6.7L DIESEL ENGINE—RUNS ROUGH/MISFIRE DURING EXHAUST REGENERATION PROCESS

TSB 13-5-9

2011-2013 F-Super Duty

Figure 1 - Article 13-5-9

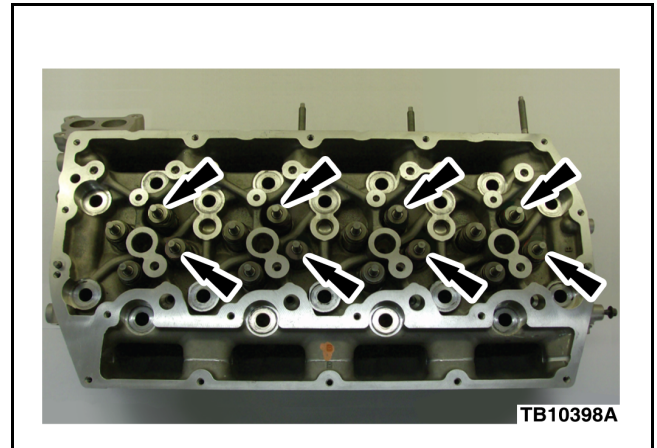
1. Did the customer indicate the message center displayed a Cleaning Exhaust Filter message prior to the concern?
 - a. Yes - proceed to Step 2.
 - b. No - this article does not apply. Refer to the Powertrain Control/Emissions Diagnosis (PC/ED) manual for normal diagnosis.
2. Using Integrated Diagnostic System (IDS) or equivalent, retrieve DTCs from the Powertrain Control Module. Are DTC's present?
 - a. Yes - this article does not apply. Refer to the PC/ED manual for normal diagnosis.
 - b. No - proceed to Step 3.
3. Remove the left hand cylinder head. Refer to Workshop Manual (WSM), Section 303-01.
4. Replace all eight (8) exhaust valves and valve seals. Refer to WSM, Section 303-01. (Figure 1)

5. Install cylinder head. Refer to WSM, Section 303-01.
